LEESTON PLAN CHANGE - RFI RESPONSE

Thank you for your letter dated 19 September requesting further information regarding Plan Change PC190062: Private Plan Change Leeston. Baseline Group has prepared the following response.

Leeston Plan Change

Figure 1: 2019 Peak Hour Traffic Volumes at Market Street / High Street Intersection

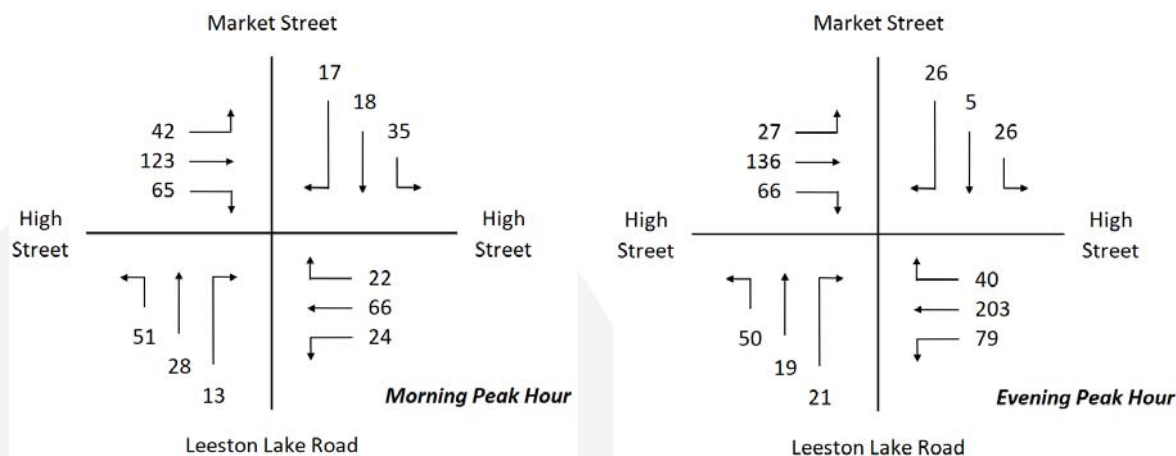
9. *The Transportation Assessment does not provide a level of service assessment of the Market Street/High Street intersection resulting from the likely increase in traffic from the west (and likely north from Leeston Dunsandel Road) as a result of the proposed plan change. There are presently concerns within the community regarding the existing level of traffic using this intersection. Therefore, given that the Transportation Assessment indicates that there will be a significant increase traffic volumes east along High Street, the assessment needs to be extended to cover the Market Street/High Street intersection and any issues identified need to be addressed, to allay or mitigate these issues.*

Please see attached response from Traffic Engineer Andy Carr, attached in Appendix 2 to this letter. The response concludes the High Street / Market Street intersection will continue to operate with a good level of service with the additional vehicles as a result of the plan change based on the traffic survey data undertaken. The intersection fits within a Level of Service category C during the peak hour. The traffic assessment concludes a Level of Service C is not unreasonable for an urban intersection during the peak hours.

The modelling shows that there is very little change in queue length on any approach, and with regard to the delay, the greatest increase is 7.5 seconds. Overall, we consider that the intersection continues to operate with a good level of service, and Level of Service C (the lowest on any approach) is not unreasonable for an urban intersection in the peak hours.

Figure 2: Traffic Generation from Plan Change Area onto Feredays Road (No Spring Place Access)

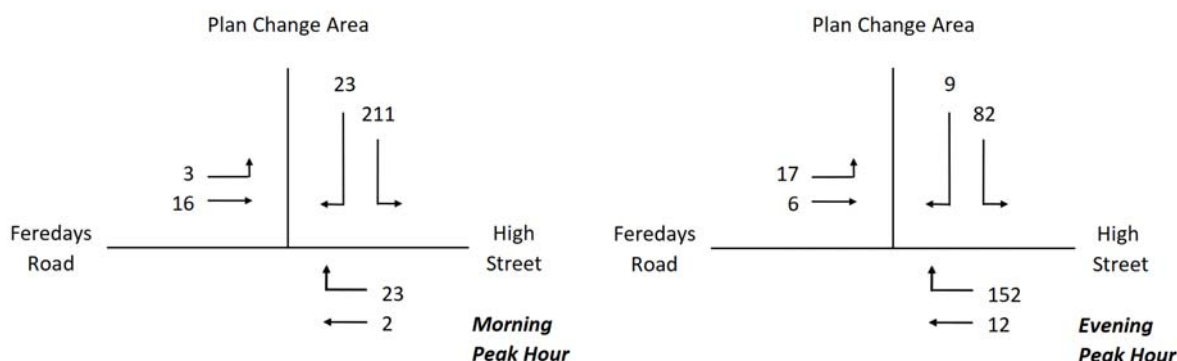
10. *A key transport connection relies on access to Spring Place. It is noted that not all land owners affected by the proposed plan change are party to the plan change, particularly the owners of Lot 3 DP 50527, being that portion of the site fronting Spring Place. Given that this is shown as an indicative primary road, what contingency is in place if this connection cannot be secured?*

The traffic response (Appendix 2) includes an assessment of the vehicle movements should the connection to Spring Place cannot be secured and concludes that the intersection of High Street and the Plan Change area would function at a Level of Service A category in the morning and evening peak hours.

The intersection provides an excellent level of service with low queues and delays, even under the expected traffic loading. In the event that the intersection was to be a roundabout (as we understand has been suggested), queues and delays would remain similarly small.

Appendix 4: Outline Development Plan

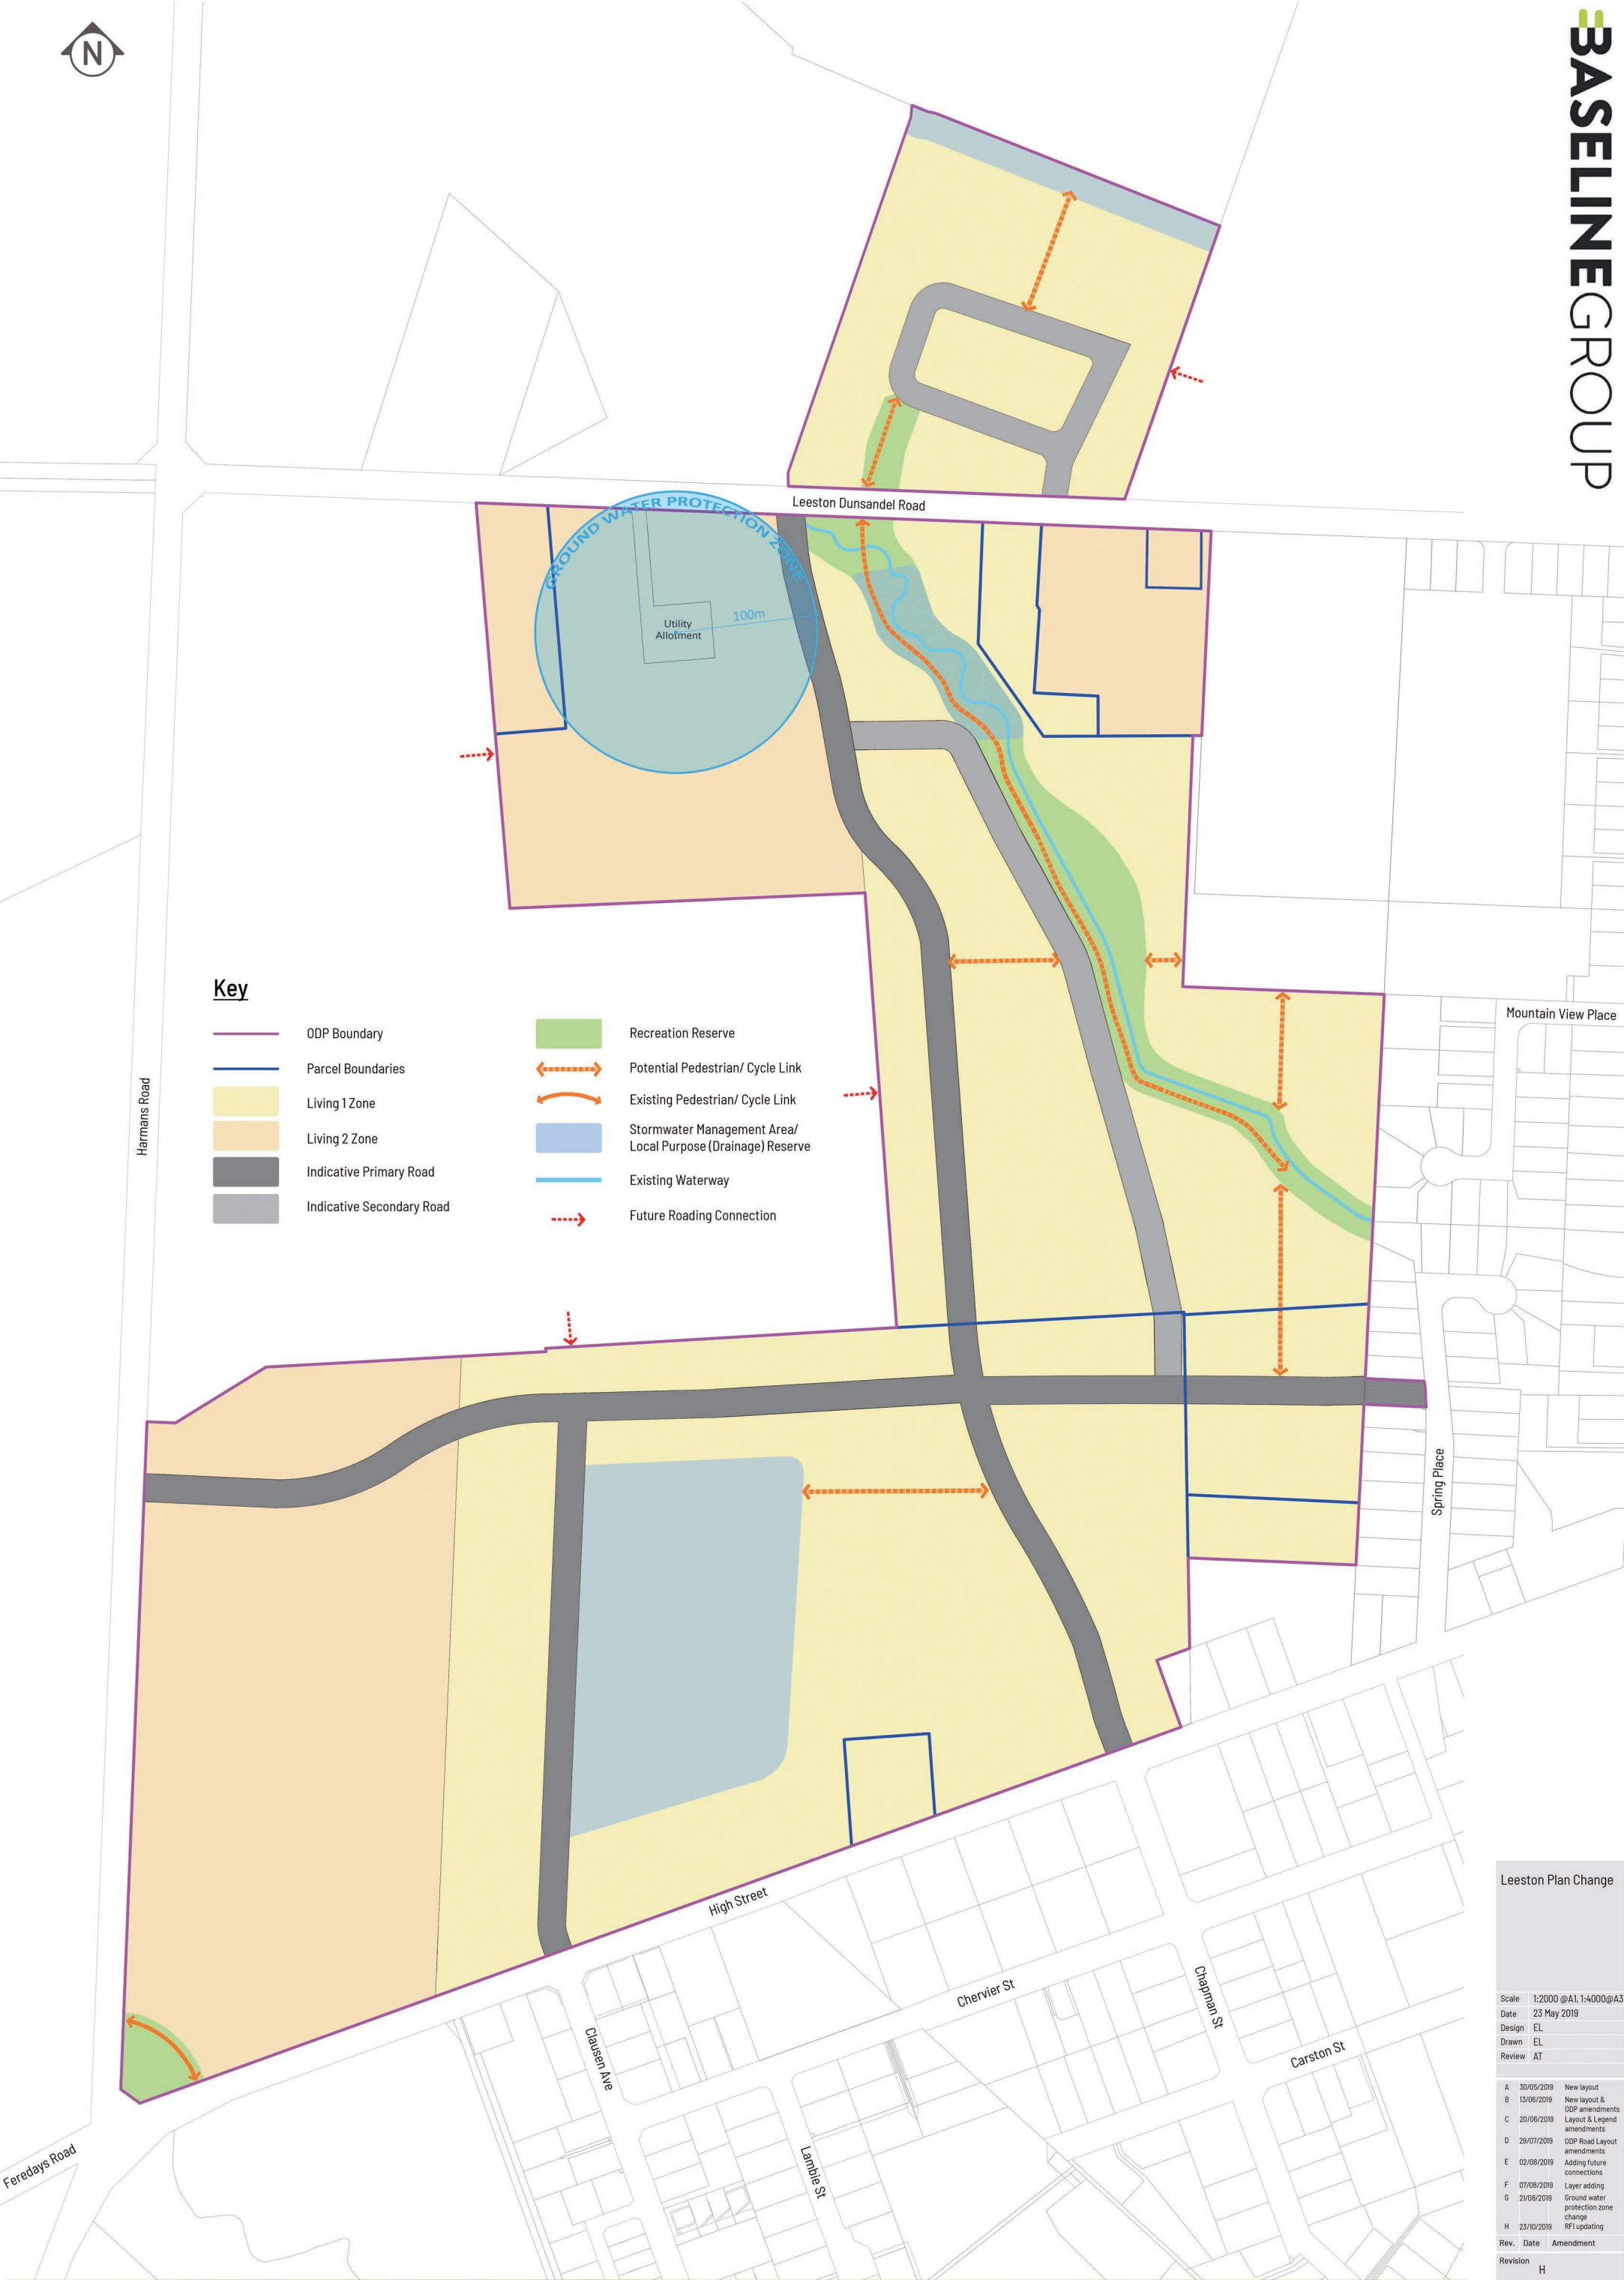
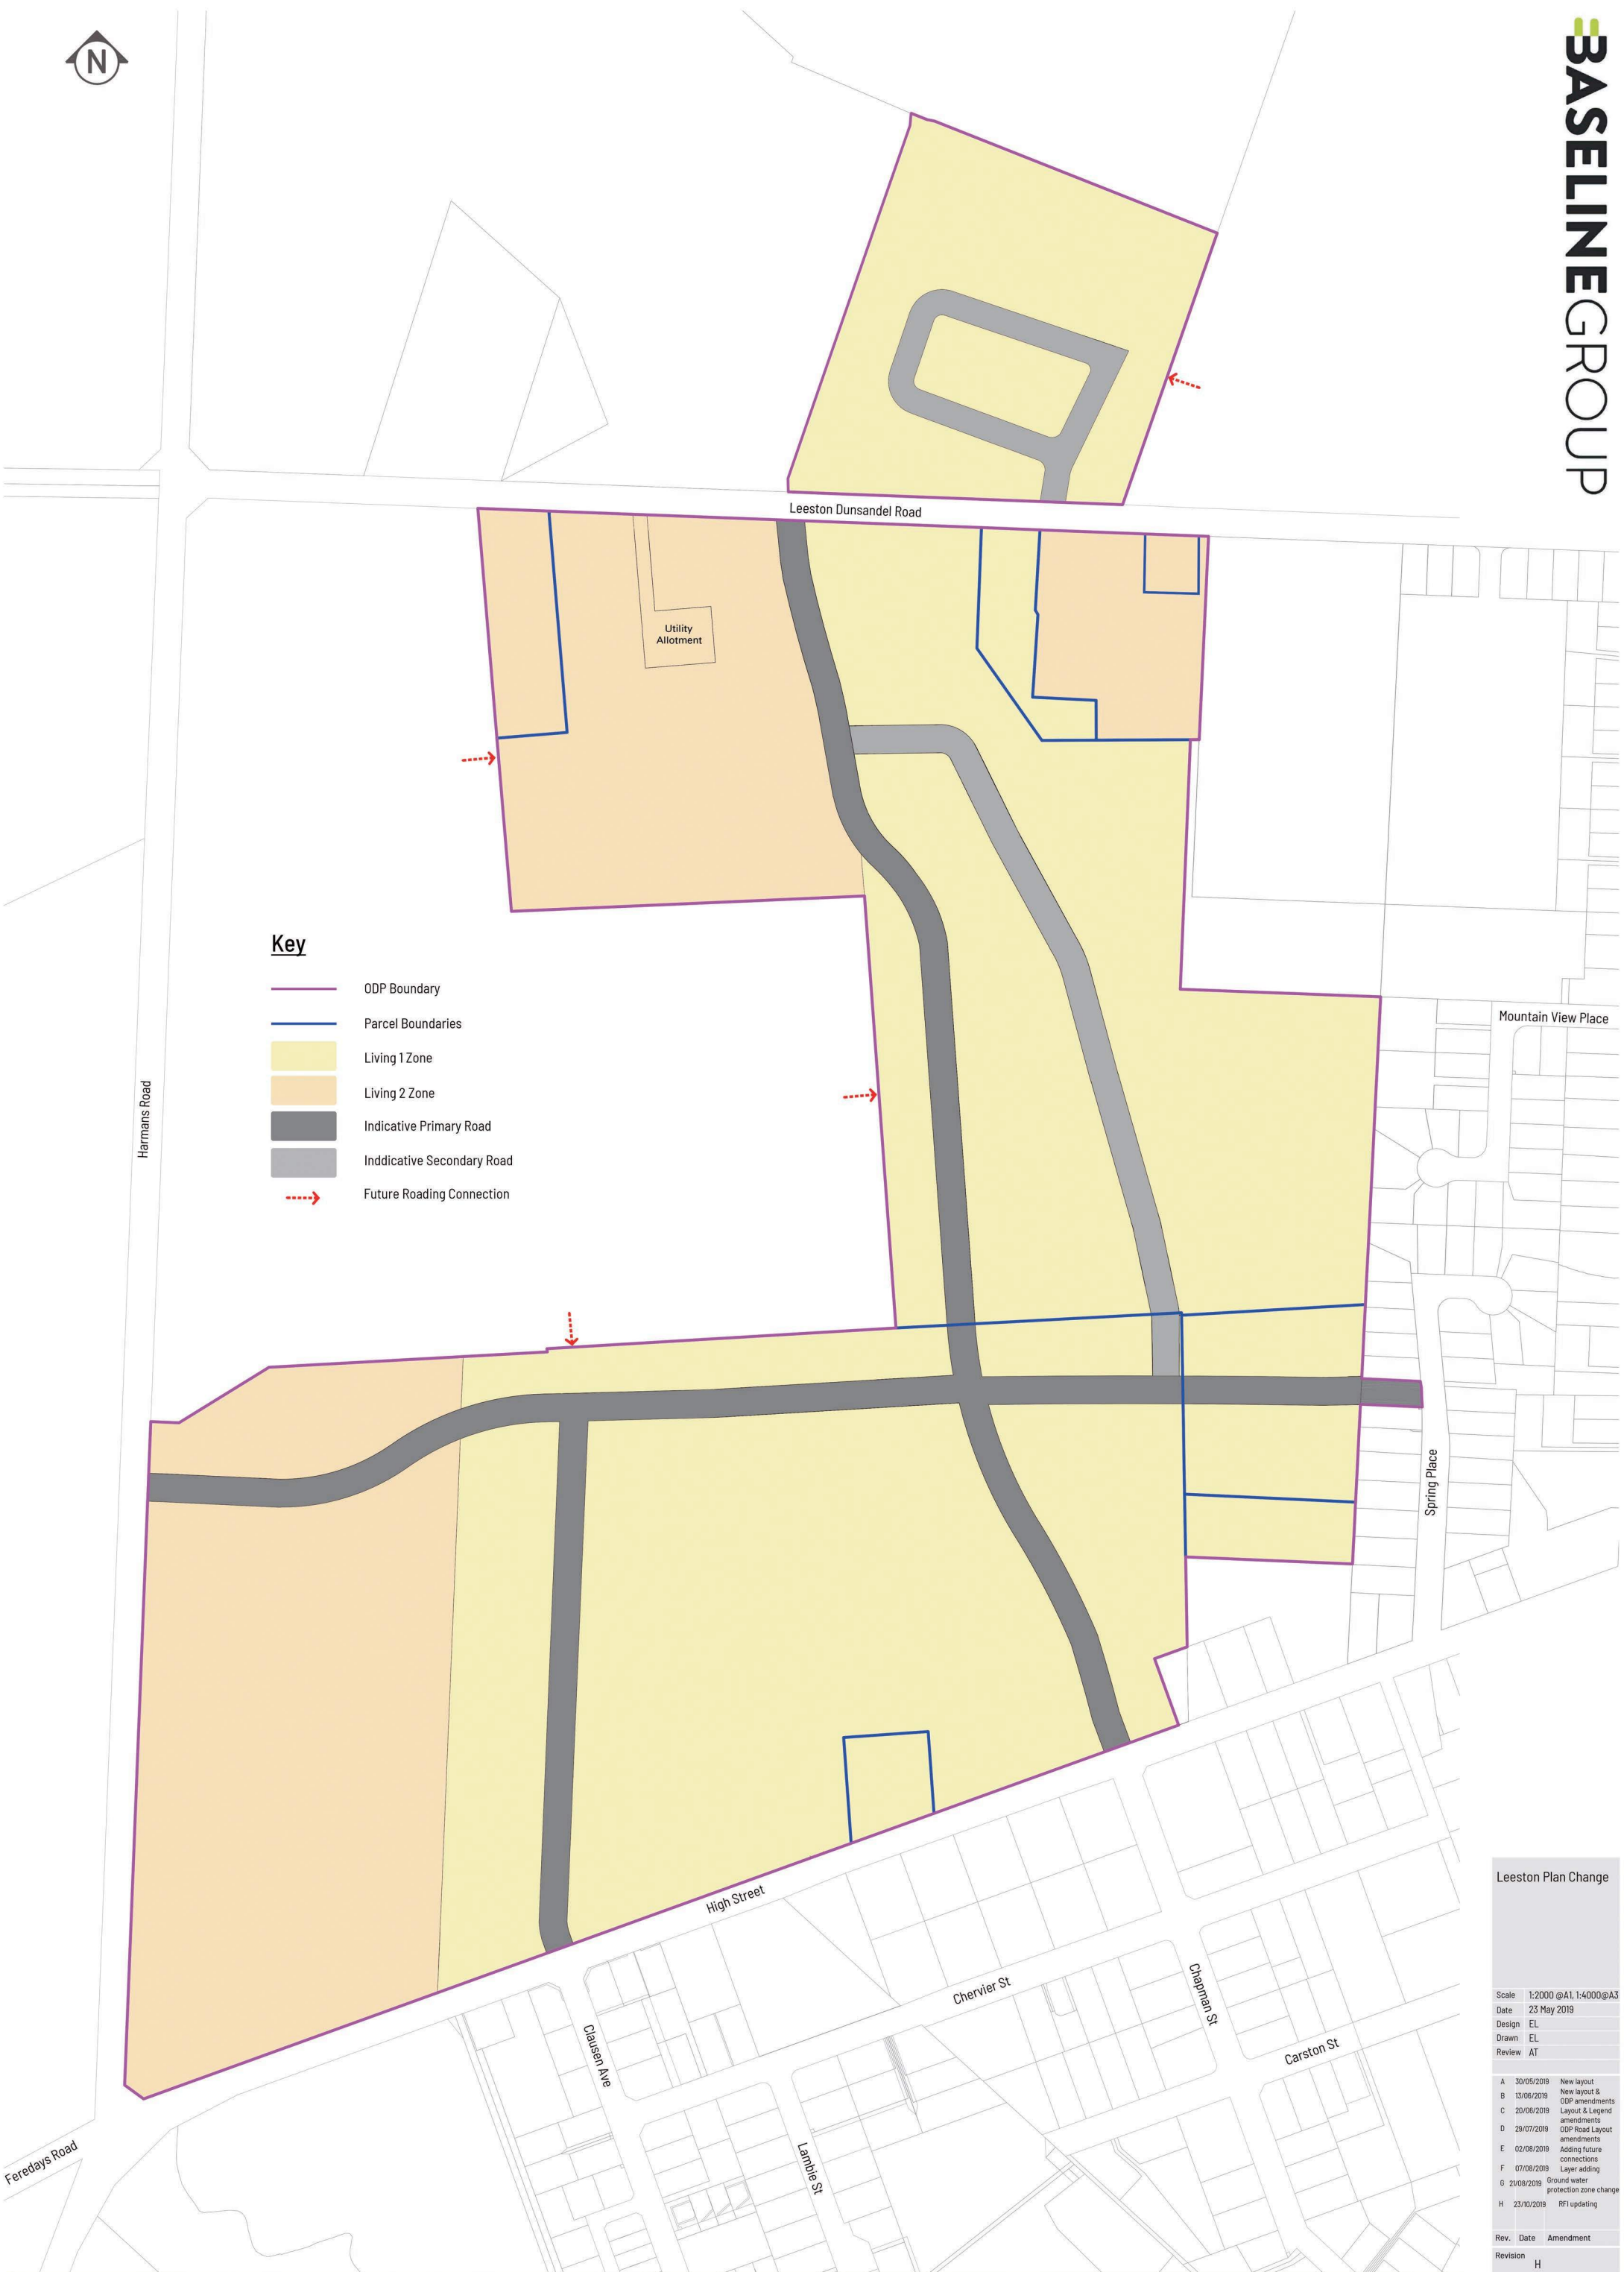
12. As highlighted in yellow below, the ODP should show a specific pedestrian/cycle link along the main reserve/water course alignment. The ODP should also show a pedestrian/cycle link from the northern part of the to the future stormwater reserve area along the northern boundary of the site.

17. There are small inconsistencies between the overall ODP and the transport network in terms of the pedestrian/cycle links. Please resolve these. It is noted that a continuous alignment is preferred.

19. The names of the surrounding roads should also be shown on the ODP.

22. The ODP should be amended to reflect any matters raised in the points above, particularly regarding roading and reserves.

These have been added to the ODP and a revised copy of the ODP is attached in Appendix 4.

The ODP has been amended to resolve the inconsistencies between the overall ODP and the transport network plan and is attached in Appendix 4.

Road names have been added to the ODP plans in Appendix 4.

The ODP plans have been amended and are attached to this letter in Appendix 4.
